Randwick Local Planning Panel (Public) Meeting

Thursday 14 May 2026

Development Application Report No. D23/26

Subject: 94 Dolphin Street, Coogee (DA/65/2026)

Figure 20: Council’s basement GFA inclusions/measurement.

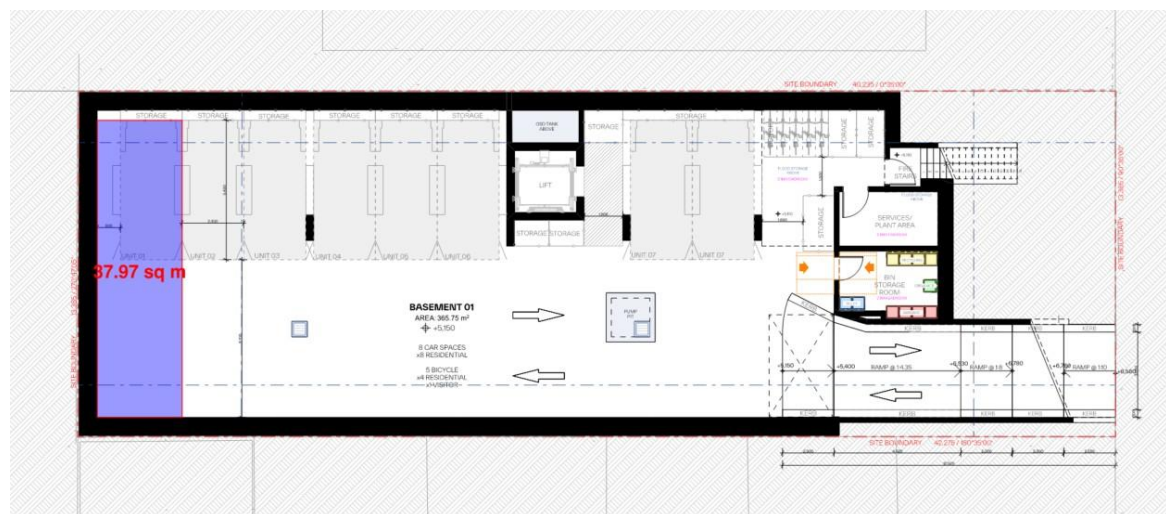
Council’s assessment has determined that the applicant’s GFA calculations are understated. In particular, Council has identified that a number of areas have been excluded from the applicant’s GFA calculation that are required to be included when assessed against the definition of gross floor area under Randwick Local Environmental Plan 2012 and the Housing SEPP.

The areas identified by Council as requiring inclusion are nominated below (see Figures 20-25):

- Internal horizontal circulation areas that do not meet the definition of open breezeways;
- Internal walls associated with the private stair in Unit 07; and
- Basement areas that exceed the extent permissible to be excluded under the relevant controls.

Figure 25: Council’s 4th level GFA inclusions/measurement.

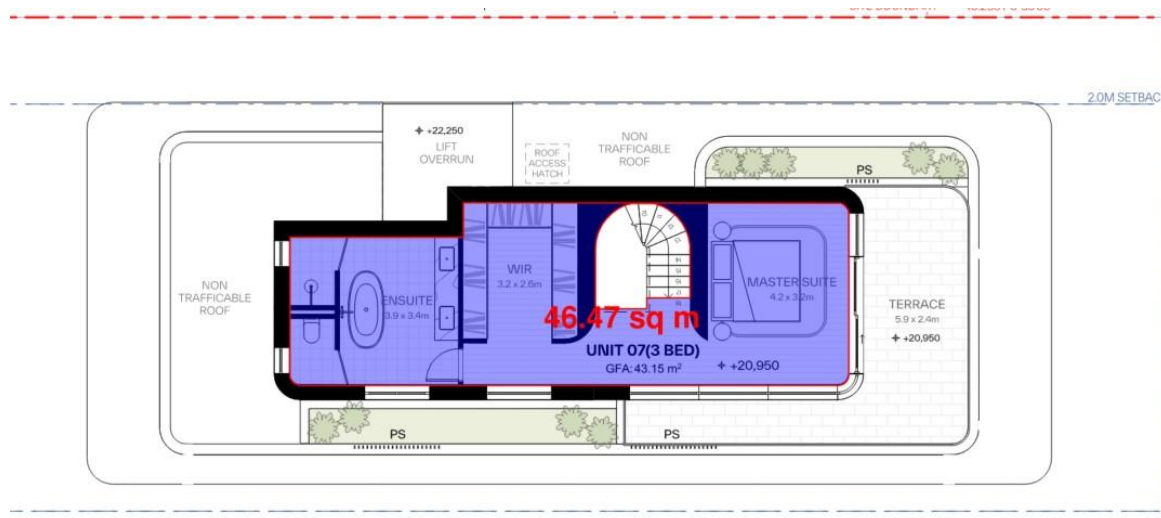
When these areas are correctly included, Council has calculated a total gross floor area of approximately 706.1 m², which equates to a floor space ratio of 1.31:1. This exceeds the maximum permissible FSR of 1.14:1 (as increased by the Housing SEPP bonus) by approximately 91.9 m² of gross floor area.
